Addendum No. 2

Subject: John M. Patterson Elementary School
2022 Classroom Modernization
SDP Contract Nos. 2022-010-G, 2022-010-P, 2022-010-E

Location: John M. Patterson Elementary School
7001 Buist Avenue
Philadelphia PA 19142

This Addendum No. 2, dated FEBRUARY 18, 2022, shall modify and become part of the proposed Contract Documents of the work of this project. Any items not mentioned herein, or affected by, shall be performed strictly in accordance with the original Contract Documents, unless modified by prior addenda.

DRAWING NO. E001

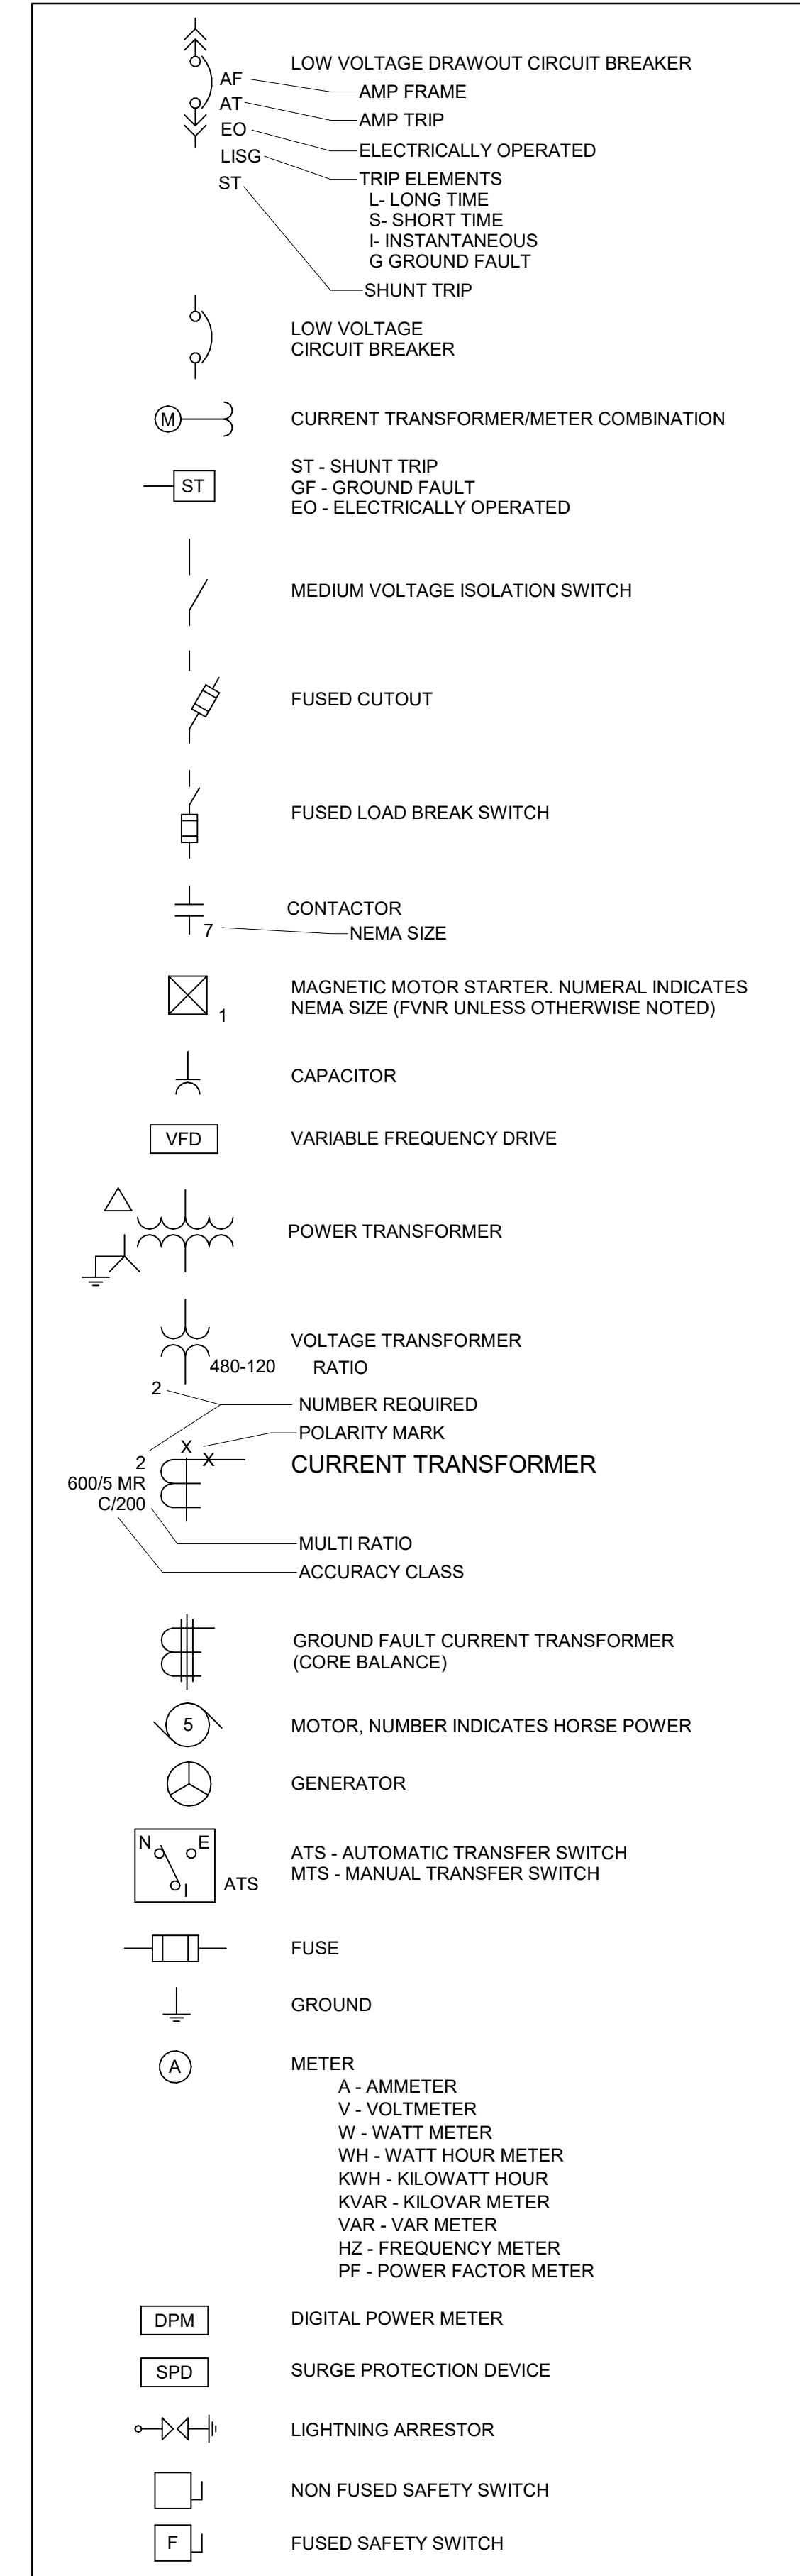
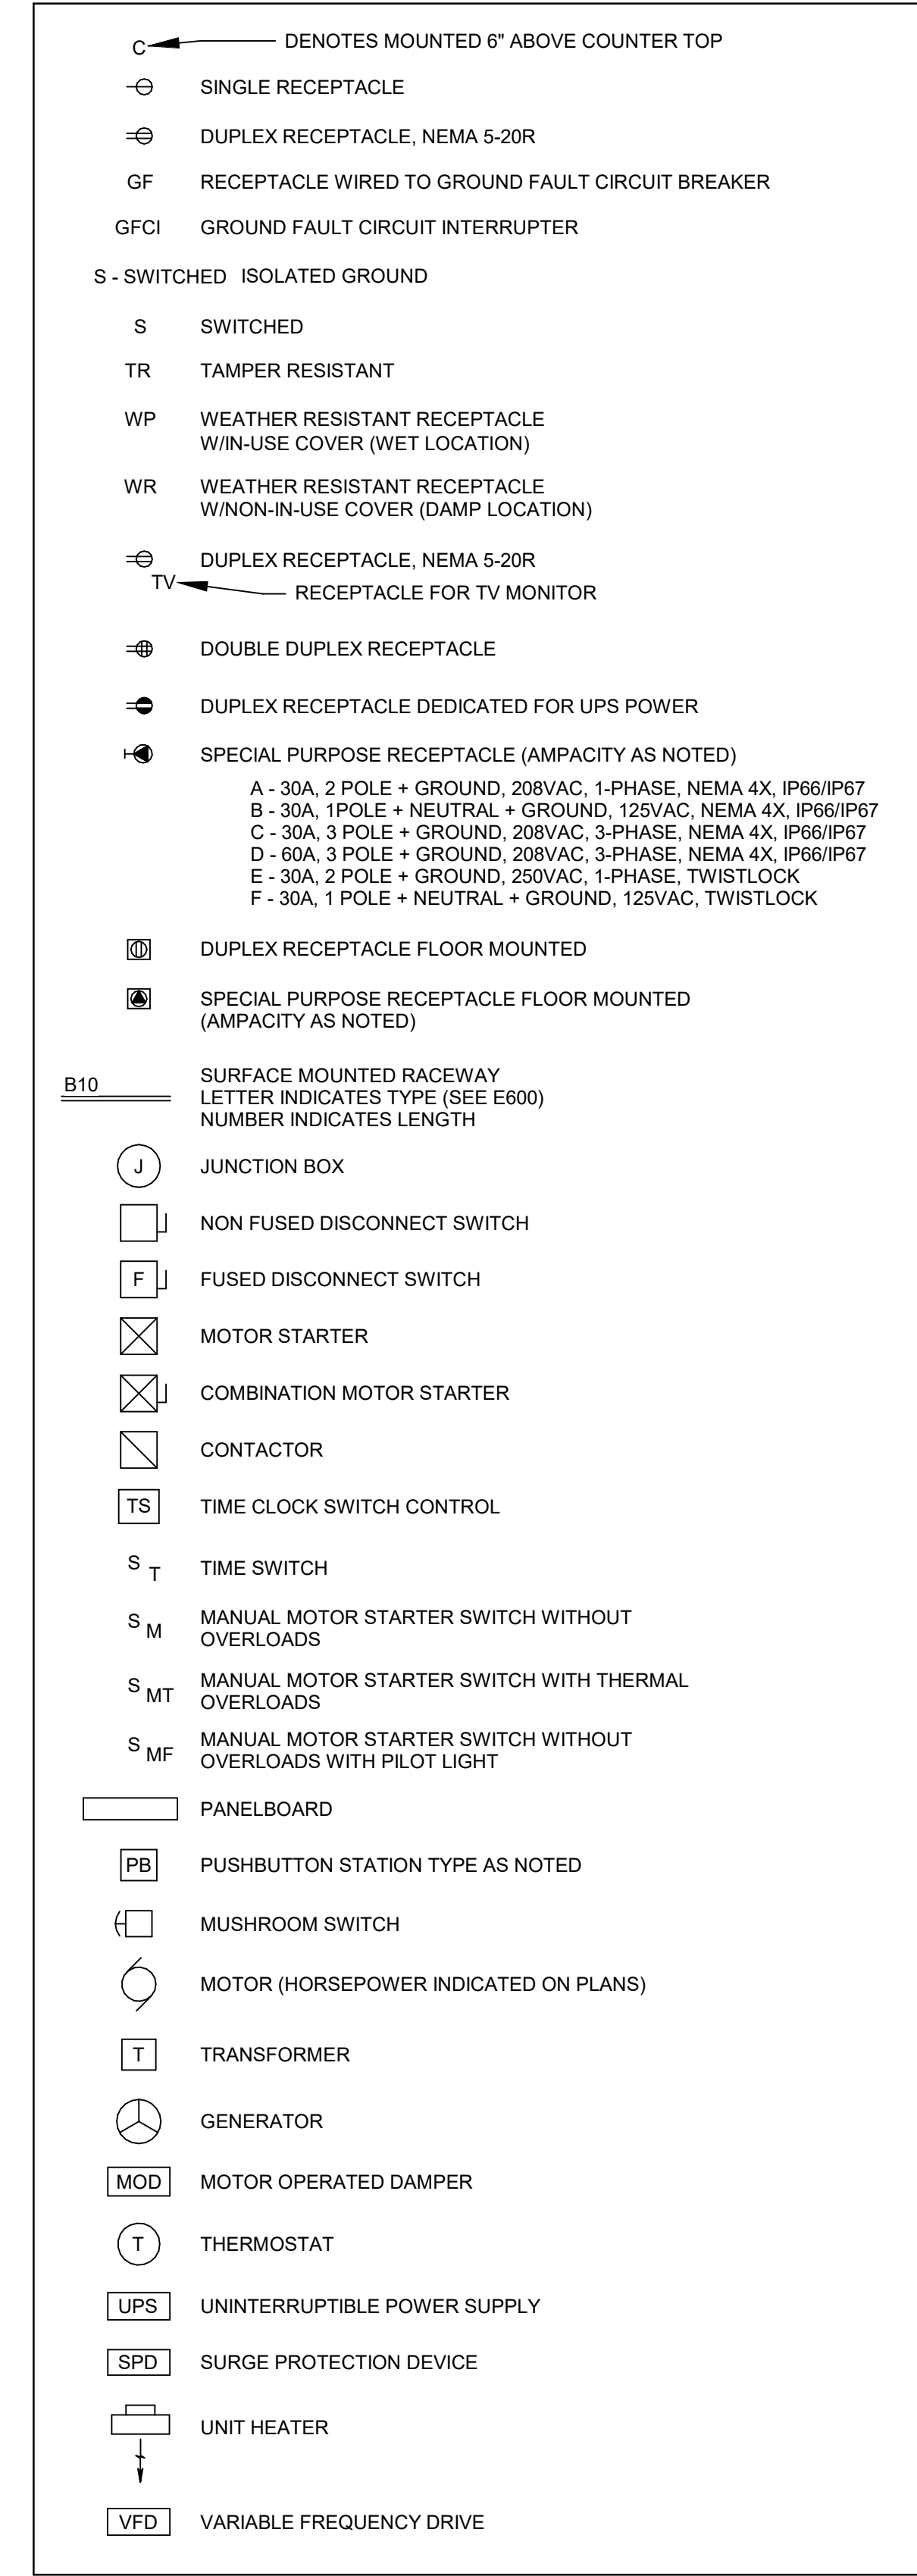
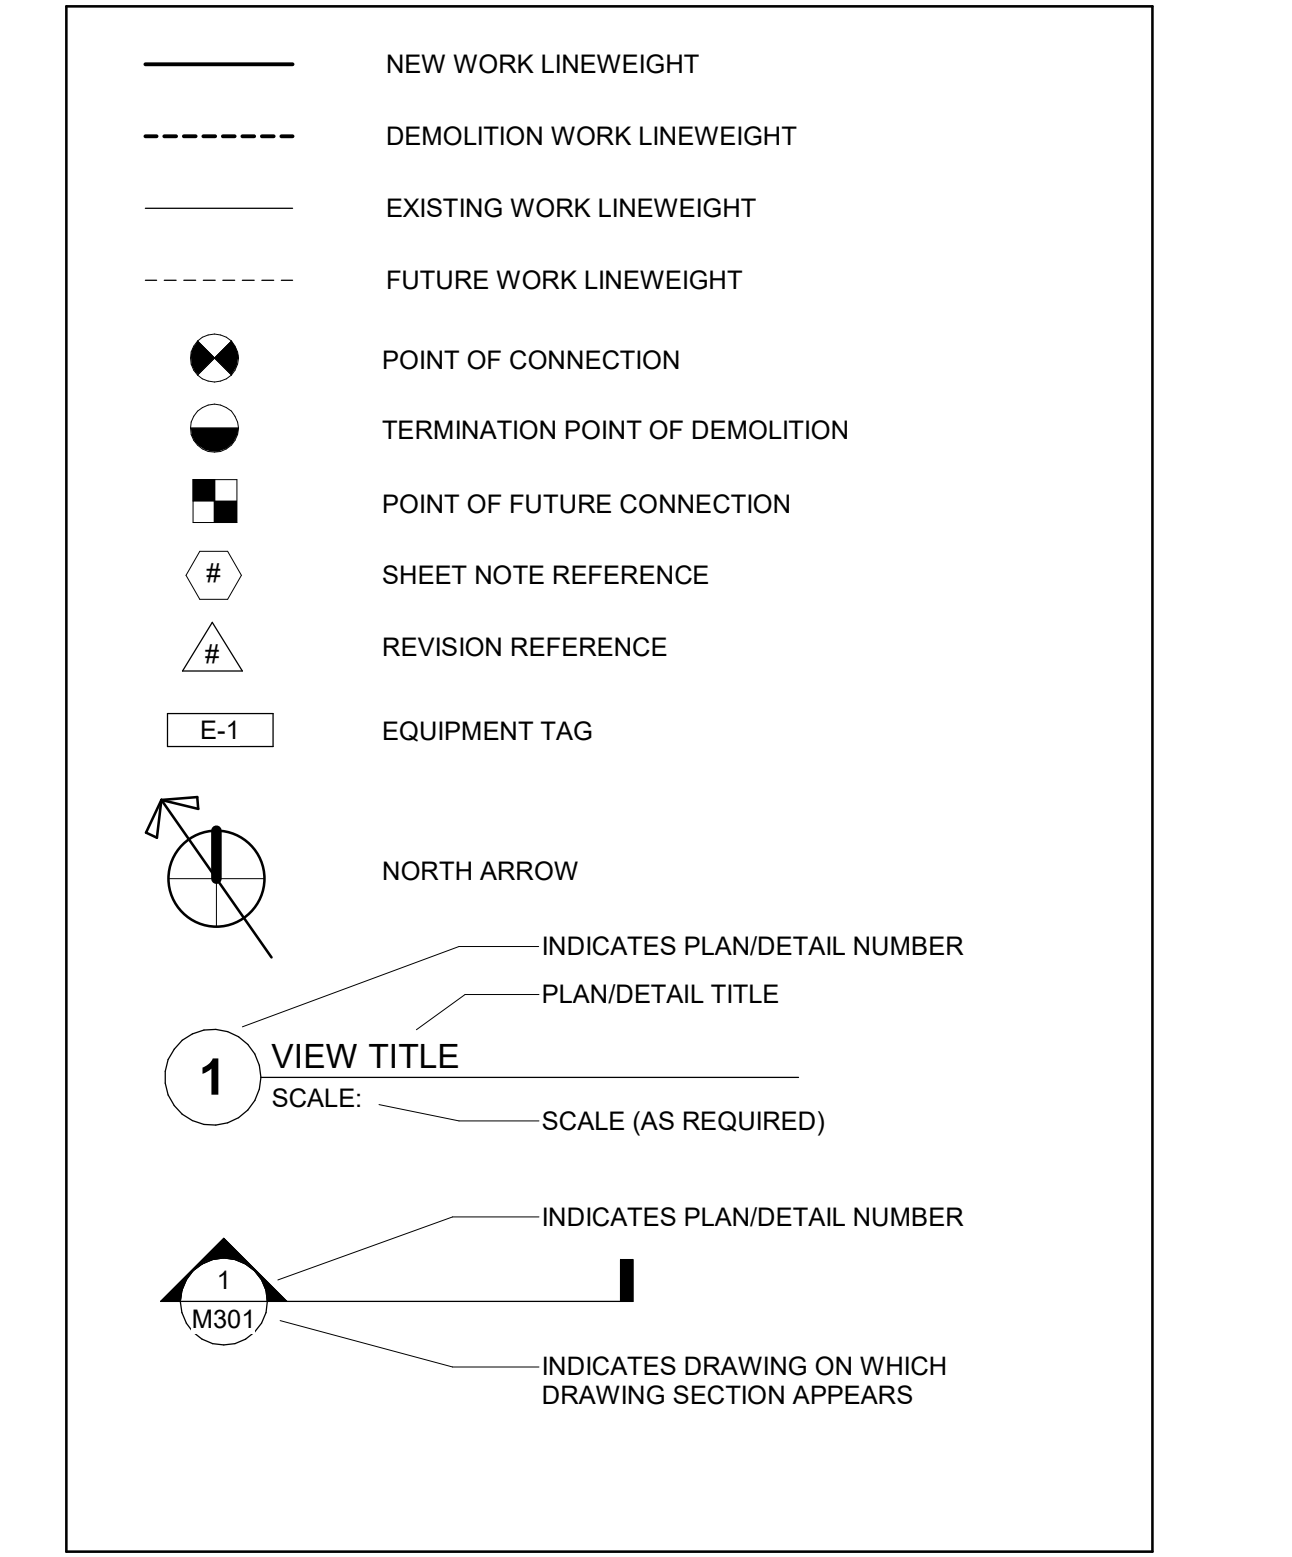
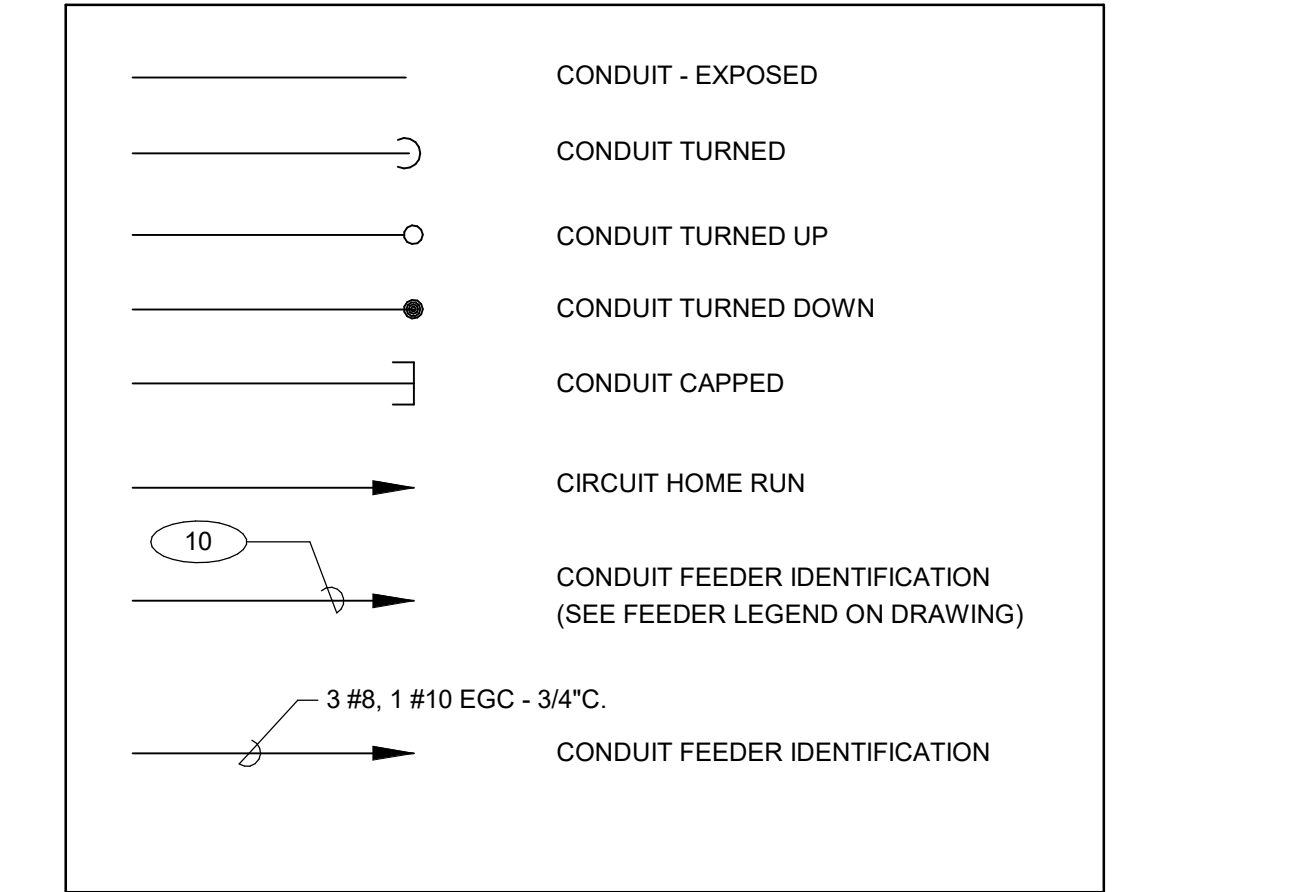
19. **Question:** Spec 260533-3.01A states all exposed circuits, including feeders, shall be provided in rigid conduit. This statement conflicts with the wiring methods described on E001, which allows EMT. Please confirm EMT is approved for exposed branch circuits and exposed feeders.

Response: EMT is permitted for exposed branch circuits and feeders.
